Southern Nuclear Operating Company
Vogtle Electric Generating Plant, Units 3 & 4
COL Application

Part 5

Emergency Plan

Revision 1

Figure ii Vogle Electric Generating Plant Site Plan

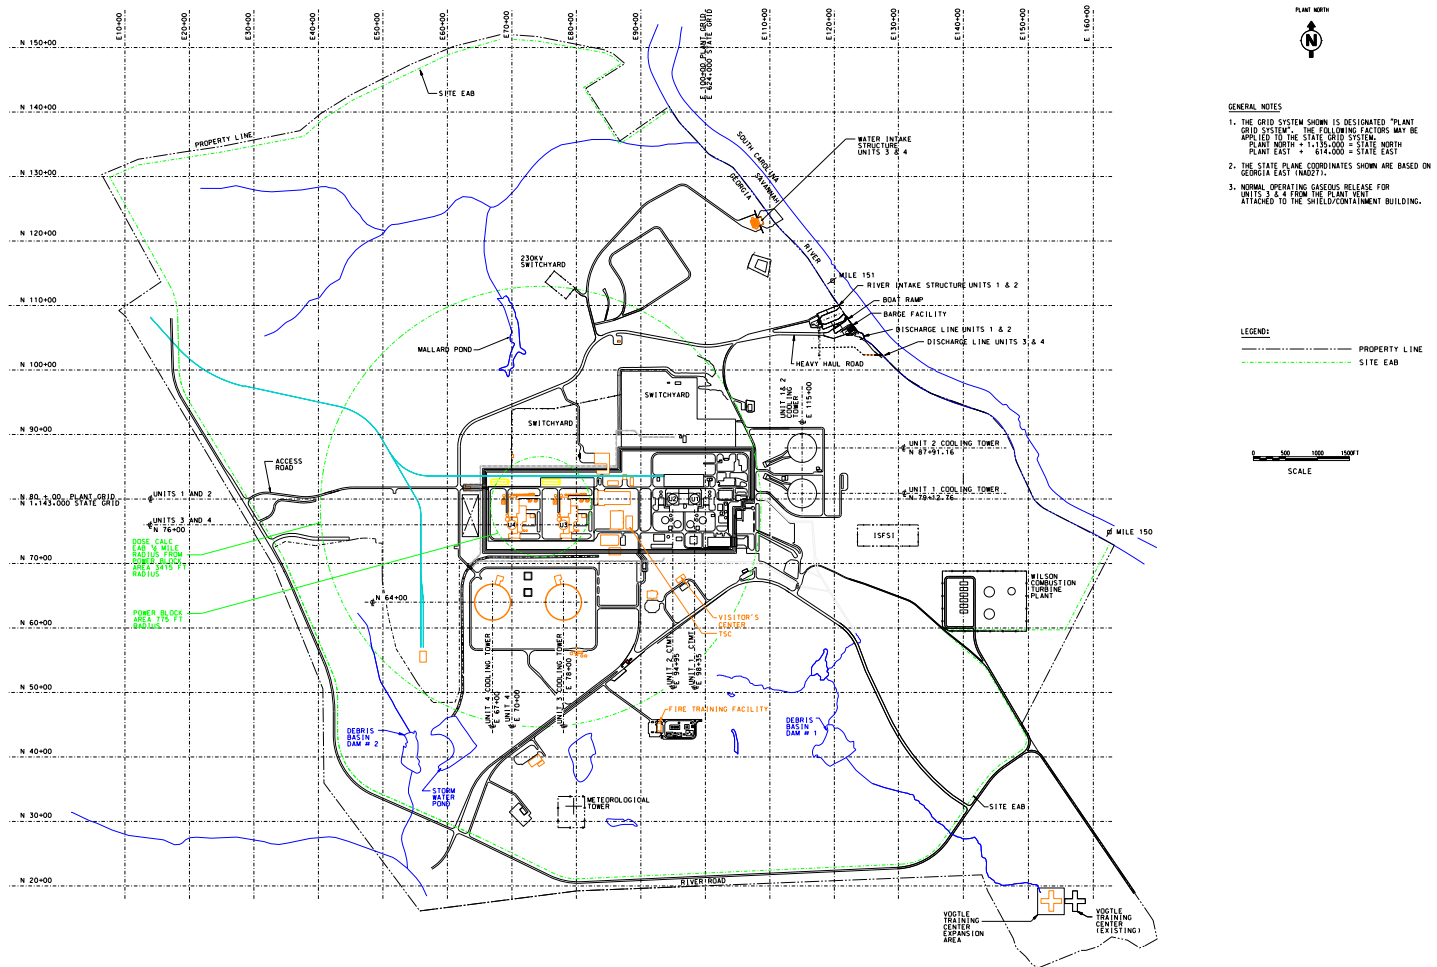
Replace Preface page xiii, Figure ii, Vogtle Electric Generating Plant Site Plan, with the attached Preface Figure ii.
